Road Safety Audit

## **Stage 1 Road Safety Audit**

**Mixed Use Development, Crown Square, Galway City**

**On behalf of Crown Square Developments Ltd**

### 2.3.1 Tuam Road Northern Kerb/footpath

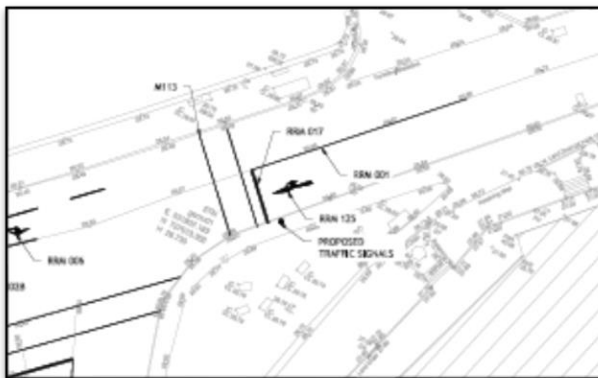
**Problem:** The existing kerb is laid to a low level and is damaged by over-running of vehicles. This is assumed to be as a result of right turning traffic being under-passed by straight ahead traffic.

**Hazard:** Impact with pedestrians on the footpath may result.

**Recommendation:** Move the existing road centre-line to the south in order to provide wider eastbound lanes on Tuam Road into this junction.

2.3.1	No	Yes	Existing defective kerblines are the responsibility of Galway City Council. Alternative road markings are proposed at this location to facilitate turning movements.	Yes

### 2.3.3 Joyce's Road Signals at Tuam Road Junction

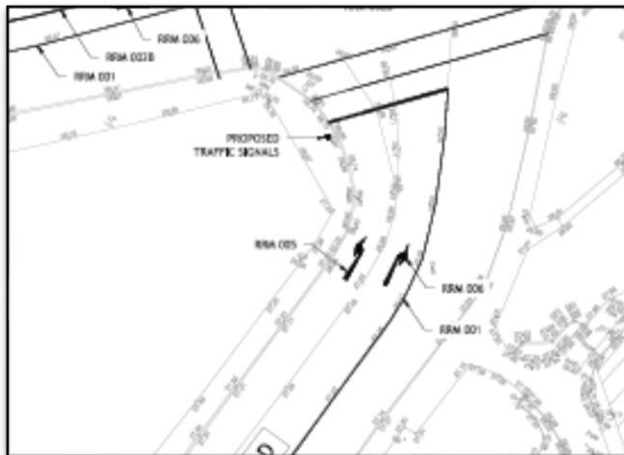
**Problem:** Northbound traffic on Joyce's Road will not have adequate forward visibility of the signal head.

**Hazard:** Overshoot into the junction may result

**Recommendation:** Redesign the junction to provide adequate forward visibility, ensuring inter-visibility between junction arms remains.

2.3.2	Yes	Yes		
2.3.3	Yes	Yes	Provide additional warning signs of junction ahead to prevent overshooting. A second primary head will be provided to the east of junction.	Yes

### 2.3.4 Tuam Road Junction – Pedestrian crossing of Joyce’s Road

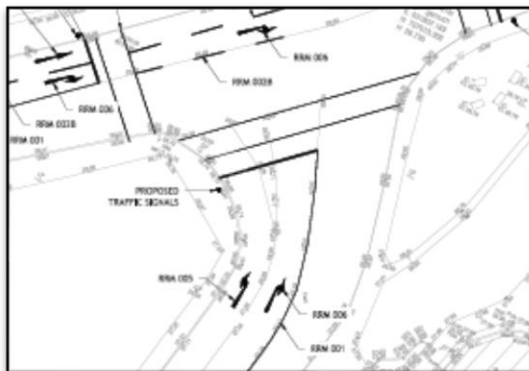
**Problem:** Pedestrians have a long road crossing to negotiate on the Joyce’s Road arm of the crossing.

**Hazard:** Frail or infirm users may have difficulty in completing the crossing in the ‘green man’ phase of the crossing. These users are at risk of vehicle impact.

**Recommendation:** Undertake vehicle swept path analysis in attempt to tighten up this arm.

2.3.4	Yes	No	Autotrack analysis has been undertaken and the radii and stop	Yes

TO BE COMPLETED BY DESIGNER				TO BE COMPLETED BY AUDIT TEAM LEADER
Paragraph No. in Safety Audit Report	Problem accepted (Yes/No)	Recommended measure accepted (Yes/No)	Describe alternative measure(s). Give reasons for not accepting recommended measure. Only complete if recommended measure is not accepted.	Alternative measures or reasons accepted by Auditors (Yes/No)
			lines are in appropriate locations to preclude vehicles entering oncoming traffic lanes.

### 2.3.5 Tuam Road Junction – Pedestrian Crossing of Joyce’s Road

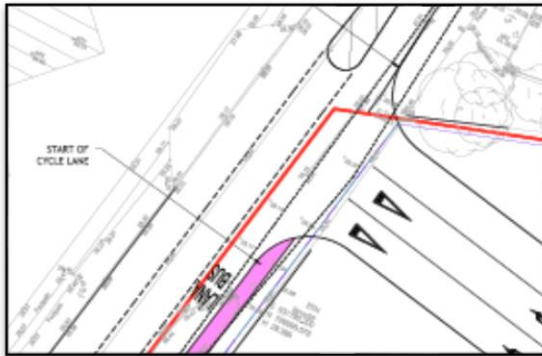
**Problem:** Pedestrians crossing southwest to northeast will have limited visibility of approaching traffic.

**Hazard:** Pedestrians who ignore the Red Man and enter the crossing are at risk if being struck by Joyce’s Road traffic who are shown a green light. This is considered a particular problem during off peak dark hours when pedestrians wrongly believe no traffic is approaching the junction.

**Recommendation:** Provide visibility for pedestrians.

2.3.5	Yes	Yes	Provide additional warning signs for pedestrians to reinforce vigilance of oncoming traffic. The client will attempt obtaining the permission of the landowner to remove the vegetation inside the boundary fence to provide visibility.	Yes

### 2.3.7 Drop-off point on Joyce's Road

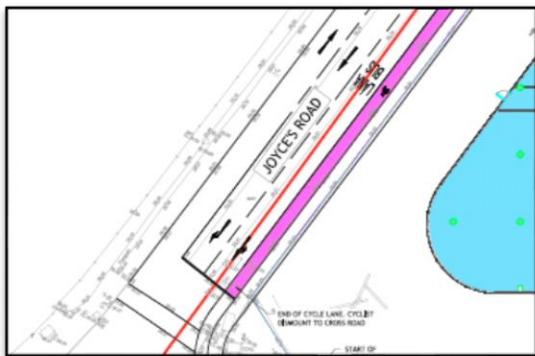
**Problem:** The drop off point on Joyce's Road is wide with shallow tapers.

**Hazard:** Multiple vehicles may stack in the drop off bay and queue out into the cycle lane and/or multiple vehicles may attempt to exit the bay at the same time. Impact with cyclists may result.

**Recommendation:** Provide suitable road markings to provide guidance in use to patrons.

### 2.3.9 Cyclist provision on Joyce's Road approach to Monivea Road Junction

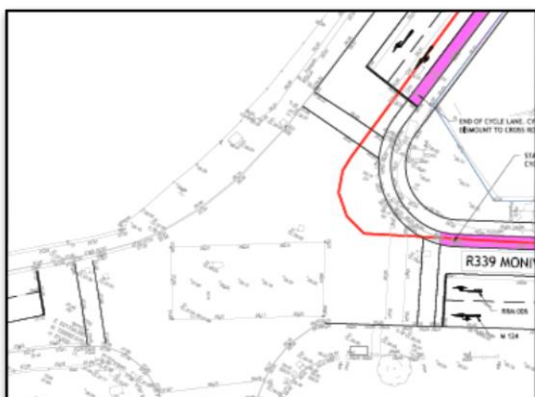
**Problem:** Cyclists wishing to turn right at this junction without dismounting are not catered for.

**Hazard:** Cyclists may stay on the cycle lane up to the junction and turn right across left turning traffic. Impact may result.

**Recommendation:** Provide suitable facilities to enable on-road cyclists to turn right safely at this junction. The design team should note Galway City Council have provided 'Box turns' elsewhere as detailed in the National Cycle Manual.

2.3.6	Yes	Yes		
2.3.7	Yes	Yes		
2.3.8	No	Yes	Drawings already updated	
2.3.9	Yes	Yes	Drawings already updated.	
2.3.10	No	No	Provide additional signs and or road markings to reinforce to drivers the need to be in the correct lane.	Yes

### 2.3.10 Westbound Monivea Road Approach to Signalised Junction

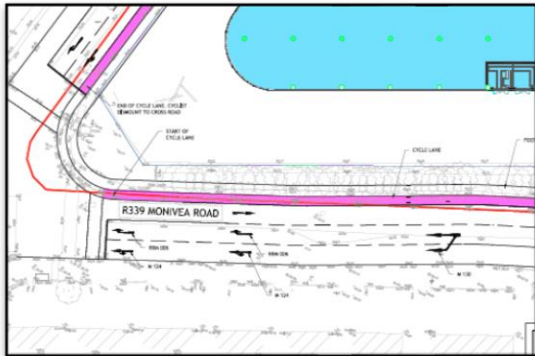
**Problem:** Some 'straight ahead' traffic may arrive at the junction in the offside lane, with others obeying the road markings and occupying the near side lane.

**Hazard:** Side impact may occur as both vehicles attempt to exit the junction into the single lane.

**Recommendation:** Widen the exit of the junction to permit dual lane exit.

### 2.3.13 Drop-off Point on Monivea Road

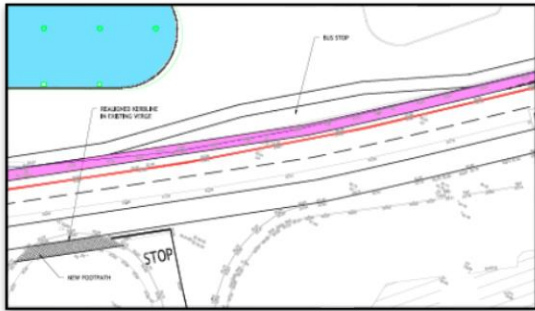
**Problem:** The drop off point on Monivea Road is wide with shallow tapers.

**Hazard:** Multiple vehicles may stack in the drop off bay and queue out into the cycle lane and/or multiple vehicles may attempt to exit the bay at the same time. Impact with cyclists may result.

**Recommendation:** Provide suitable road markings to provide guidance in use to patrons.

### 2.3.15 Termination of Cycle Lane at Development Junction

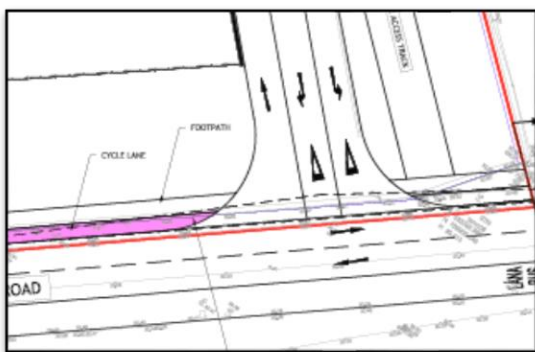
**Problem:** Cyclists departing the cycle lane will be close to the nearside road edge.

**Hazard:** Vehicles exiting the development may proceed to the edge of the main carriageway prior to yielding. Impact with cyclists may result.

**Recommendation:** Extend the cycle lane to the far side of the development junction.

### 2.3.16 Fire Tender Access of Monivea Road

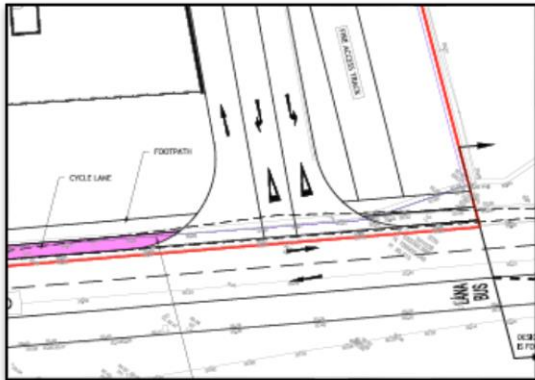
**Problem:** No details of the interface of the fire tender access with the public road have been shown.

**Hazard:** Errant public access to the lane may result.

**Recommendation:** The design team should ensure only the fire tender can access this lane.

### 2.3.18 Greenway Development to South of Monivea Road

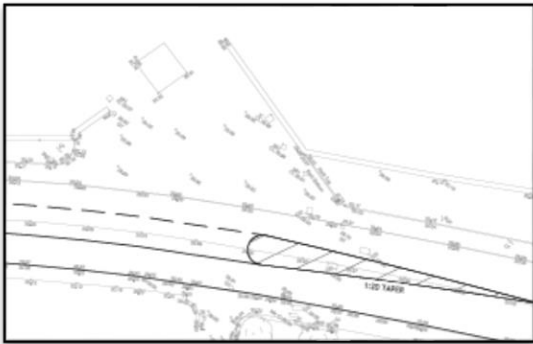
**Problem:** No details are given for road junctions to the ongoing Greenway Development to the opposite side of Monivea Road.

**Hazard:** Conflicting traffic movements may result.

**Recommendation:** The Design Team should ensure these proposals do not interfere with the Greenway Development.
